ACCESS REPORT

DEVELOPMENT APPLICATION

“SUMMER HILL FLOUR MILL” – STAGE 1

Prepared By Mark Relf
28th February 2013

Site 1 (Residential/Retail) and Site 2 (Through site Link to Light Rail Stop)

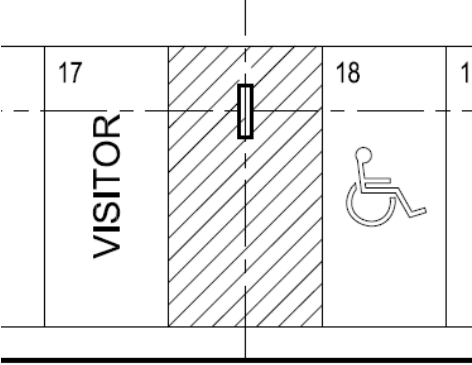
BCA / DDA Access Code Review	Complies
<p>proximity to the eastern entry gate this entrance is not required to be accessible.</p> <p>(d) Edward Street proposes several on-street parking spaces with individual stairway entrances to the townhouse apartments directly adjacent.</p> <p>2. Overall, the development proposes four (4) “common entrances” with two (2) being accessible which satisfies Part D3.2 and Table D3.1 of the BCA.</p> <p>3. Residential Entry Lobbies – The abovementioned accessible entrance provide access to the ground floor podium and the two (2) lifts which travel to all levels of the apartment buildings and basement car park in accordance with AS1428.1 to satisfy D3.2 and Table D3.1 of the BCA.</p>	<p>N/a</p> <p>YES</p> <p>YES</p>
<p>4. Site 2. Through Site Link To Light Rail Stop – The Stage I plans propose a pedestrian Through Site Link to the future light rail stop, which indicates a moderate undulating slopes not exceeding 1:20 as the accessway commences at RL10.250 and then travels east for approximately 40 metres to RL9.10 and then at 1:21 to 9.75 and the boundary of works @RL10.90.</p> <p>5. This pathway will comply with AS1428.1 and will be consistent with Part H2 of the BCA relating to accessible pedestrian infrastructure.</p>	<p>YES</p> <p>YES</p>

<p>6. Site 2 includes a small café with an outdoor door dining area, landscaping and a small amphitheatre.</p> <p>7. The café will provide on-grade level entry access from the adjacent pathway @RL9.75 and incorporate a unisex accessible toilet and outdoor deck area. The construction certificate documentation shall confirm the design complies with AS1428.1 to satisfy Parts D3.2 and D3.3 and F2.4 of the BCA and DDA Premises Standards.</p> <p>8. The amphitheatre indicates several stairways that will require detailing at the construction certificate stage to ensure the stair risers are setback from any transverse pathway by at least 650mm at bottom landings and 350mm at top landings to ensure handrail extensions to do project into the pathways to comply with AS1428.1 to satisfy Part D3.3 of the BCA.</p>	<p>YES</p> <p>YES at CC stage</p> <p>YES at CC stage</p>

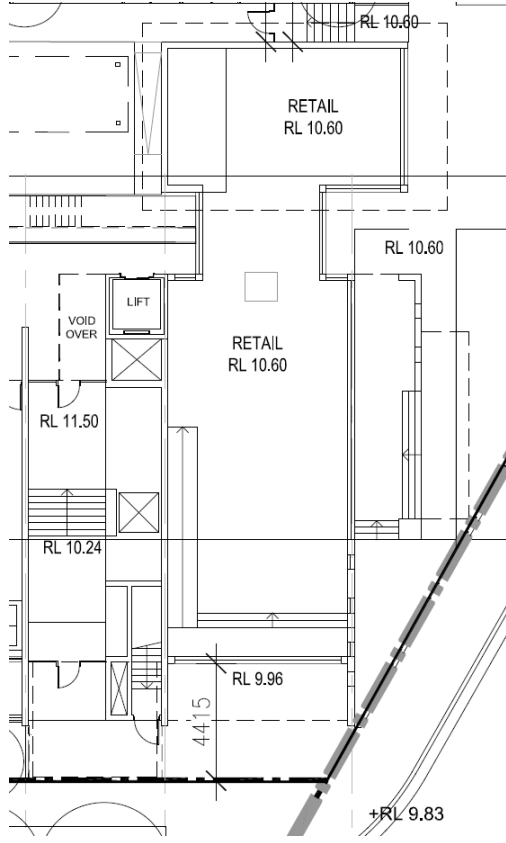
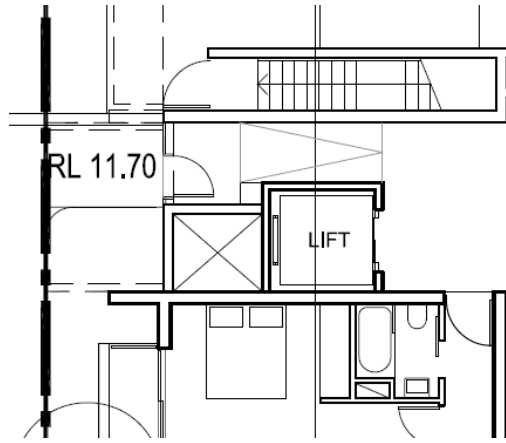
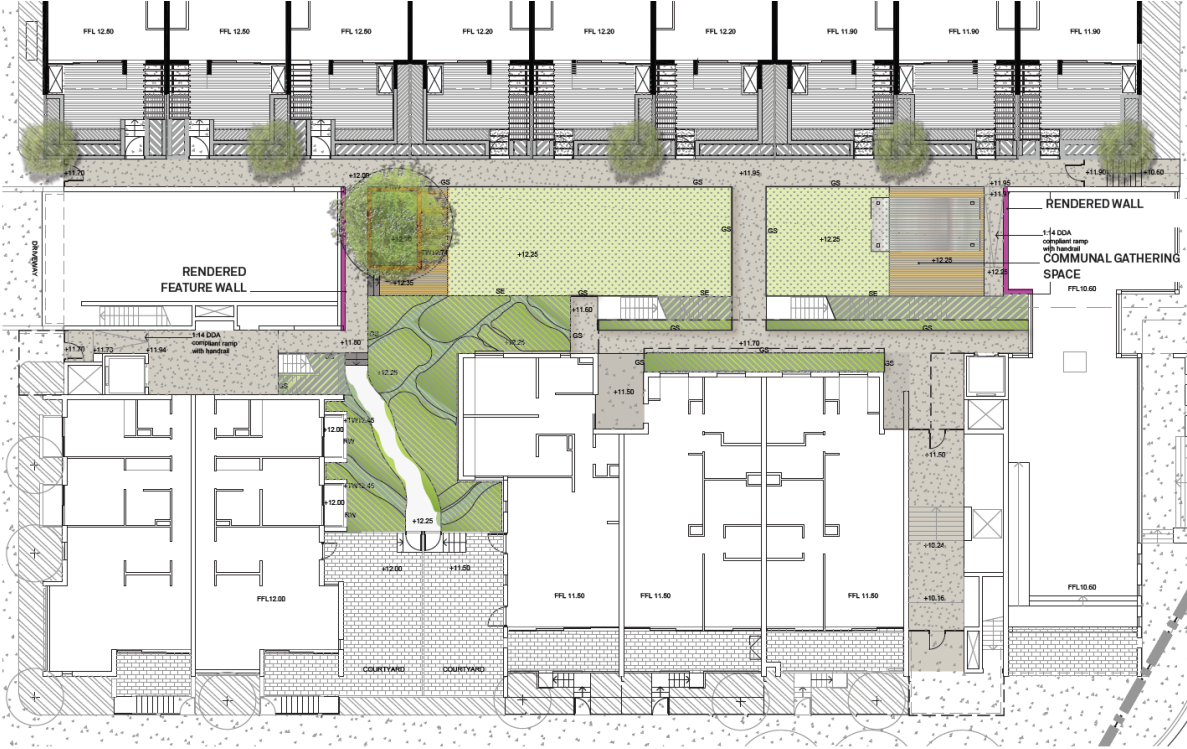
BCA / DDA Access Code Review		Complies
<p>9. The development proposes 53 basement car spaces which includes 2 spaces for the retail/commercial areas of the development.</p> <p>10. There will be at least 1 accessible space for the retail/commercial areas designed to comply with AS2890.6 and located within the basement adjoining the Lift for the northern buildings, which could be space 39 or 18 as illustrated.</p>		<p>YES at CC stage</p>

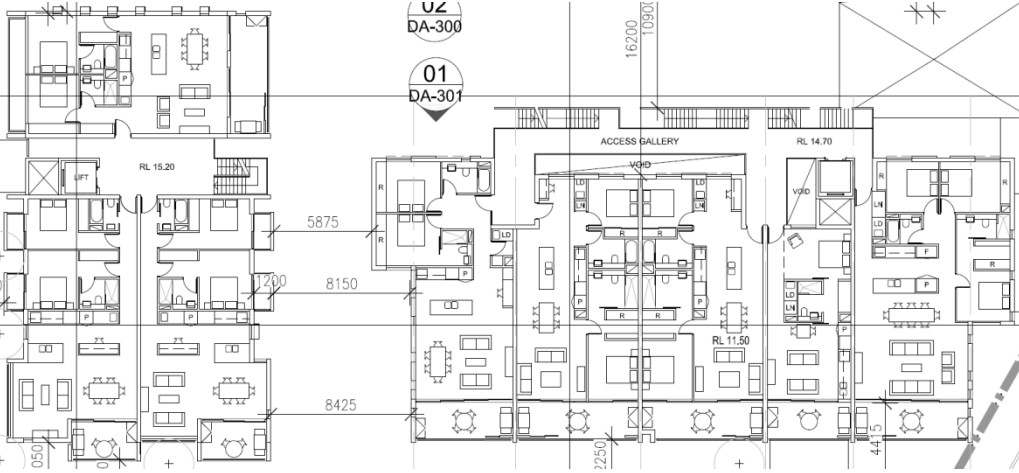
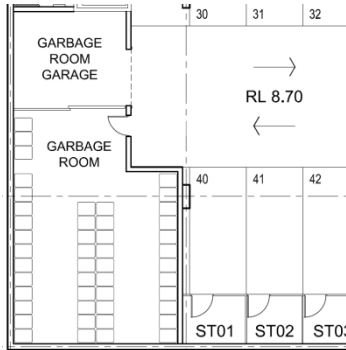
BCA / DDA Access Code Review		Complies
<p>11. Ground Floor Retail - The ground floor retail / commercial area provides an internal 1:14 ramp from the entry @RL9.960 to the internal floor level of RL10.600 which has an open plan layout enabling access to all areas in accordance with AS1428.1 and Part D3.3 of the BCA.</p> <p>12. Future DA shall be prepared relating to the internal fitout of this area, including sanitary facilities.</p>		<p>YES</p> <p>YES at CC stage</p>
<p>13. Doors and Door Hardware - The construction documentation shall confirm 920mm minimum doors (butt hinge) providing 850mm clear opening width with lever handles, 20 N maximum force to open doors, which have appropriate luminance contrast to adjoining walls and level thresholds in accordance with AS1428.1 to satisfy Part D3.3 of the BCA.</p>		<p>YES at CC stage</p>

Pre Adaptation Plan

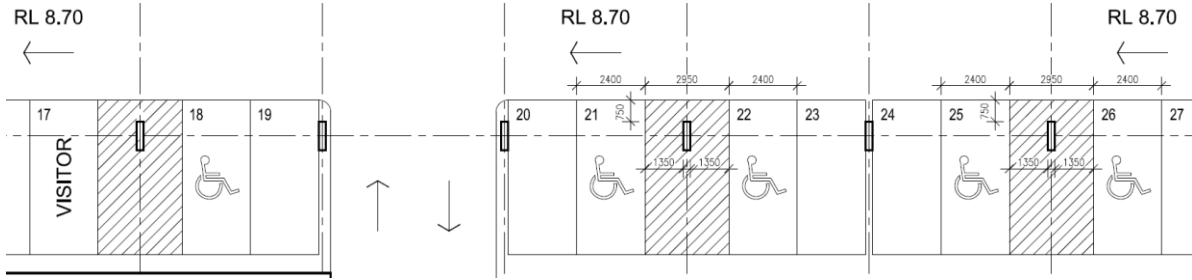
Clause	Adaptability Assessment	Compliance
AS4299 Clauses 3.3 and 3.5	<p>Common Resident Entry Lobbies – Section A describes the site accessways to all residential apartments which confirms equitable access to the adaptable units in accordance with AS1428.1 to satisfy Parts D3.2/D3.3 of the BCA.</p> <p>Overall I am satisfied that the principal building entrances and access to the lifts will provide appropriate access for people with disabilities in accordance with AS1428.1 / AS4299.</p>	YES
AS4299 Cls 3.3.3, 3.7 &	<p>Car Parking</p> <p>The development proposes four (4) accessible Resident car spaces</p>	YES

Clause	Adaptability Assessment	Compliance
	<p>within the basement car park to be allocated to the adaptable apartments and one (1) accessible space for Visitors.</p> <p>With respect to adaptable parking for adaptable units, the plans propose 2400mm width spaces adjoining 2400mm minimum width shared areas (see example below) which enable side vehicle transfers in and out of vehicles by people with mobility aids in accordance with AS2890.6 and the intent of AS4299.</p> <p>The car park surface is level @RL8.70 and the layout provides level accessways to the two lifts.</p>	<p>YES</p> <p>YES</p>
		<p>YES</p>
	<p>The car park shall provide 2200mm minimum height entry and aisle height and 2500mm height over the accessible spaces in accordance with AS2890.6 and the intent of AS4299.</p>	<p>YES</p>
AS2890.6	<p>With respect to accessible visitor parking, the plans propose 2400mm width spaces adjoining a 2400mm shared area to enable transfers in and out of vehicles by people with mobility aids in accordance with AS2890.6.</p>

AS4299 Clause 3.8	<p>Letterboxes</p> <p>The development will provide the letter boxes within the residential lift lobbies and will provide at least 1550mm X 1550mm level landing areas in front of all letter boxes for circulation and access to comply with AS4299.</p>	<p>YES at CC stage</p>
Part E3.6 of the BCA	<p>Lift Access</p> <p>The plans indicate the lift cars will be at least 1400mm X 1600mm to satisfy Part E3.6 of the BCA and Council's Access DCP and will be detailed to comply with AS1735.12 – <i>Lifts For People With Disabilities</i>.</p>	<p>YES</p>
AS4299 Clauses 4.3.1, 4.3.2 and 4.3.3	<p>Accessible entry – The front entrances to these units provide a level threshold and will be detailed with a 920mm minimum doorway to achieve 850mm clear opening width.</p> <p>With respect to doorway circulation spaces the plans show the required 1500mm-1700mm X 1600mm externally in the common corridors and internally with 530mm minimum latch side clearance with a 920mm min entry door, as specified by AS4299.</p>	<p>YES</p> <p>YES</p>

AS4299 Cls 4.3.7	<p>Interior: general – The pre adaptation plans provide open plan living areas with direct access to the main bedroom doorways in accordance with AS1428.1/4299.</p>	<p>YES</p>

Clause	Adaptability Assessment	Compliance
	<p>Doors and Door Hardware</p> <p>While the plans do not indicate 920mm external door widths, 870mm internal door widths and lever handles these details should be provided at construction drawing stage to confirm compliance.</p>	YES at CC stage
AS4299 Clause 4.7	<p>Living and Dining rooms – The plans show combined living and dining area on a single level with sufficient area to provide a 2250mm diameter turning area to comply with this clause.</p>	YES
AS4299 Clause 4.5	<p>Kitchen – The kitchen post adaptation plans provide the required 1550mm minimum circulation space adjacent to the benches and appliances to comply with AS4299 requirements.</p> <p>With regard to the “adaptability” of the kitchen the pre-adaptation plan provides an appropriate layout of sink, fridge, wall oven, cooktop while the post adaptation plan proposes a height adjustable workbench that is readily adaptable and satisfies the “ease of adaptation” guidelines outlined in section 2 – Performance Objectives of AS4299.</p> <p>Therefore, subject to confirmation of the installation of kitchen cupboards, appliances and the like at the construction documentation stage it is apparent that the kitchen will comply with AS4299.</p>	YES

AS4299 Clause 4.6	<p>Main bedroom – The post adaptation plans show the main bedroom provides an area of at least 4700mm x 3000mm providing 1540mm X 2070mm circulation space on each side of the queen bed and a 1000mm minimum at the foot of a queen sized bed with appropriate doorway circulation spaces to enter/exit the room and access the robe area to satisfy AS4299/1428.</p>	YES
AS4299 Clause 4.7	<p>Bathroom – The post adaptation plans show the ensuite layout will be at least 2300mm X 3000mm which provides ample area to comply with AS1428.1/4299.</p> <p>The construction certificate plans shall confirm an appropriate layout of sanitary facilities with dual plumbing services for the toilet relocations and shower/basin modifications to comply with AS1428/4299 to satisfy the performance requirements of AS4299.</p>	YES
AS4299 Cls 4.4.3	<p>Toilet – With respect to the provision of visitable toilets the plans indicate that the abovementioned adaptable bathrooms will provide a design with a size and layout that enables the toilet to comply with AS4299 by providing 1250mm X 900mm in front of the WC pan.</p>	YES

AS4299 Clause 4.8	<p>Laundry – The laundry facilities provide adequate space for a washing machine/drier while the adjacent area facilitates the required minimum 1550mm X 1550mm clear circulation space in front of the appliances to comply with AS4299.</p>	YES
AS4299 Clause 4.11	<p>Garbage – The plans illustrate a garbage room in the basement that provide 1500mm X 2000mm+ internal circulation area and at least 530mm latchside clearance then the design will provide appropriate access to comply with AS1428.1 and satisfy Table D3.1 and Part D3.3 of the BCA.</p>	YES

Clause	Adaptability Assessment	Compliance
AS4299 Cls 3.5(b)	<p>Outdoor Private Open Space – The plans show outdoor balcony terrace areas adjacent living areas for each of these units with sliding doors for convenient access and an approximate, which provide at least 2200 X 7200, which is adequate to perform a 180 degree wheelchair manoeuvre.</p> <p>While the plans do not indicate thresholds the construction drawings will confirm the capability for installing in-fill decks and 35mm height threshold ramps over sliding door tracks to comply with AS1428/4299.</p>	YES
